PHASE I INSPECTION REPORT
NATIONAL DAM SAFETY PROGRAM

**DELMOE LAKE DAM
BUTTE, MONTANA
JEFFERSON COUNTY
MT-117**

PREPARED BY:
CH2M HILL
BELLEVUE, WASHINGTON

Re: CH₂M Hill Dam Safety Inspection report on Lake Delmoe Dam MT-117.

PLATE 5
DELMORE LAKE DAM
SECTION

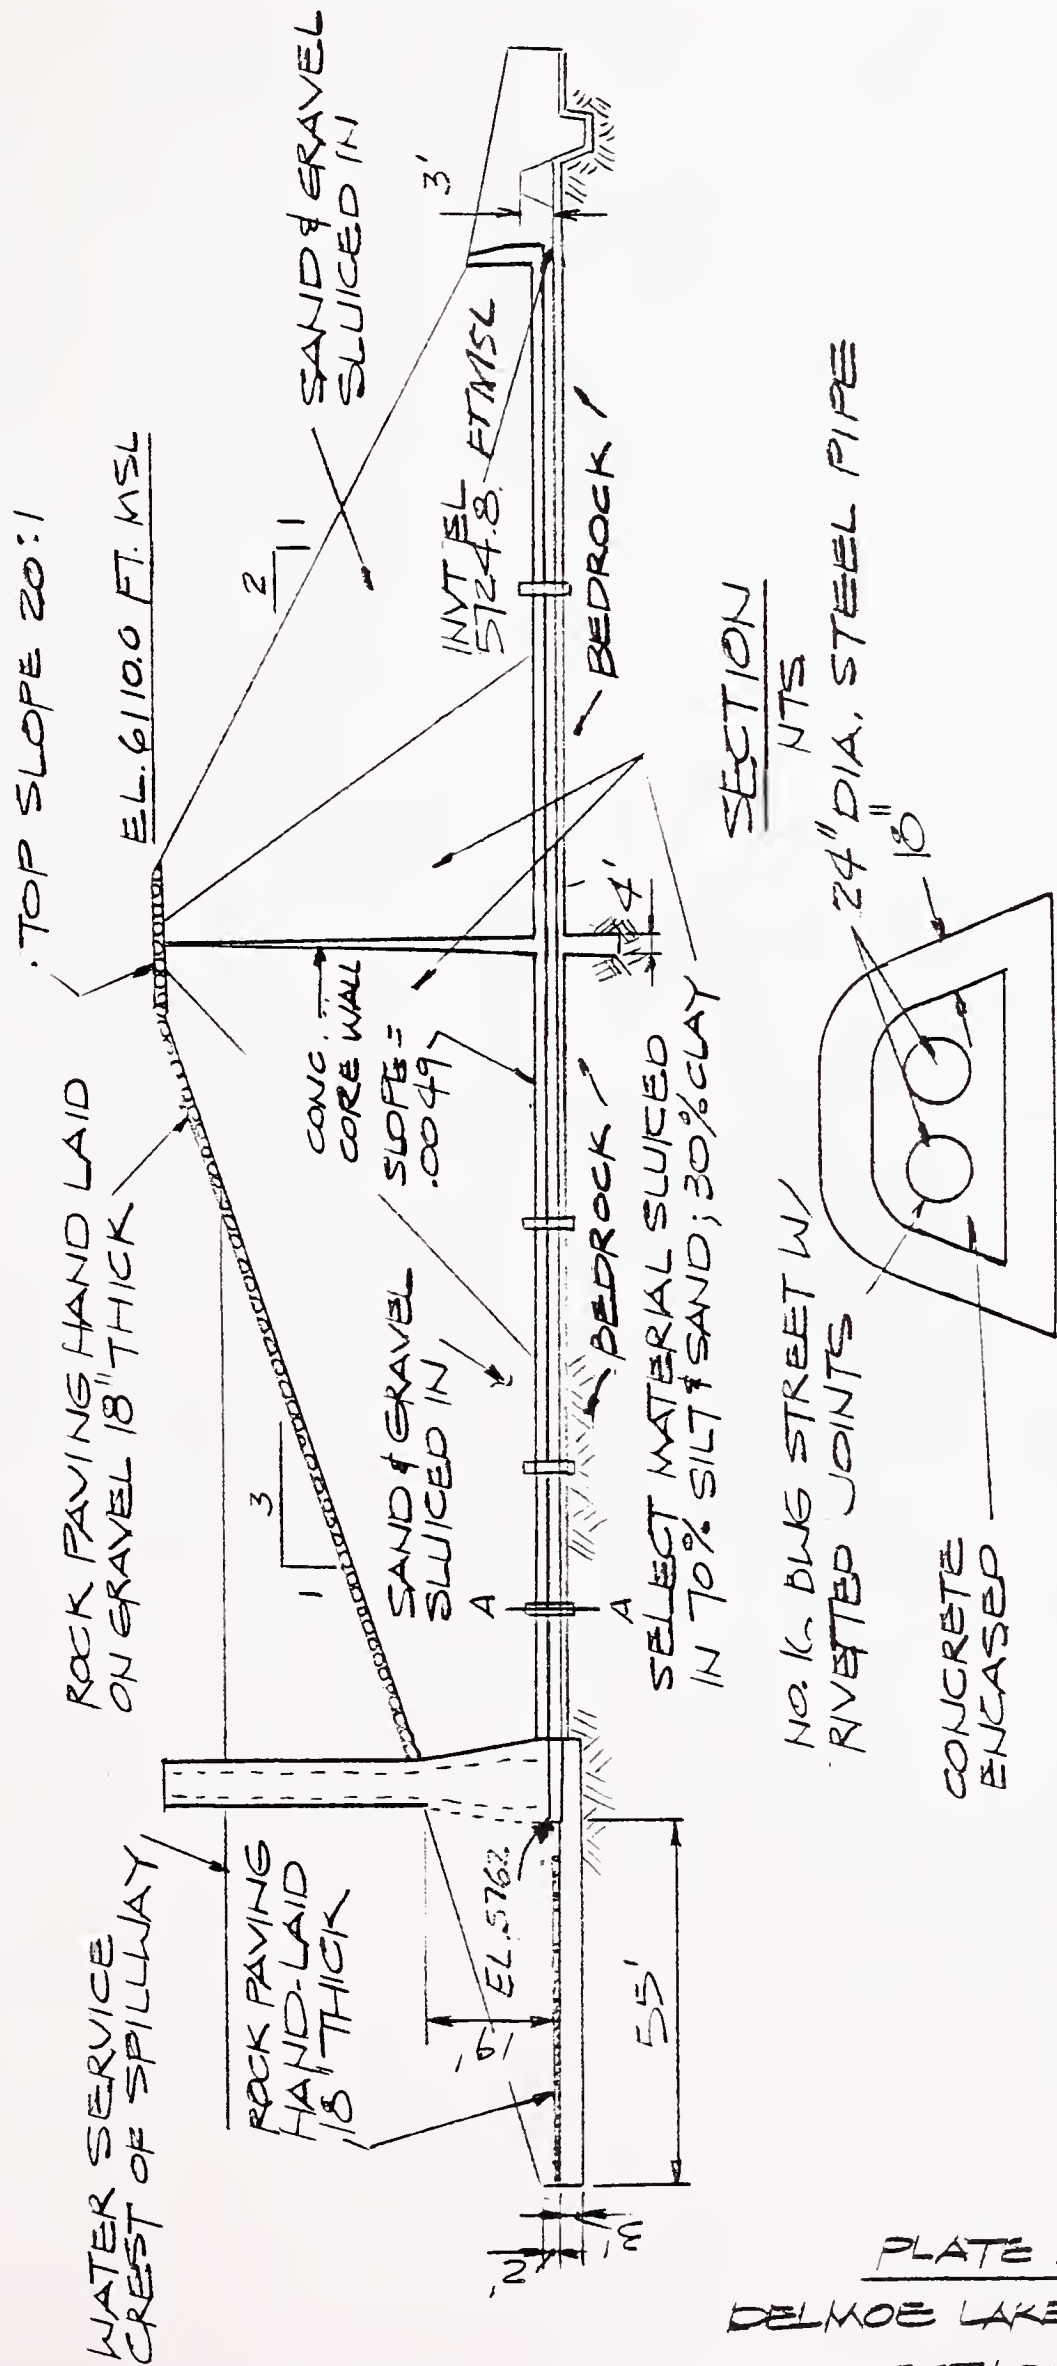
(2) In Sub-Section 2.3.1 Dam; the fourth sentence in the first paragraph reads "The plans are not clear whether the concrete diaphragm was extended to rock.". This sentence should be clarified since the previous sentence states that the concrete diaphragm is founded on rock throughout the length of the low-level outlet and control tower.
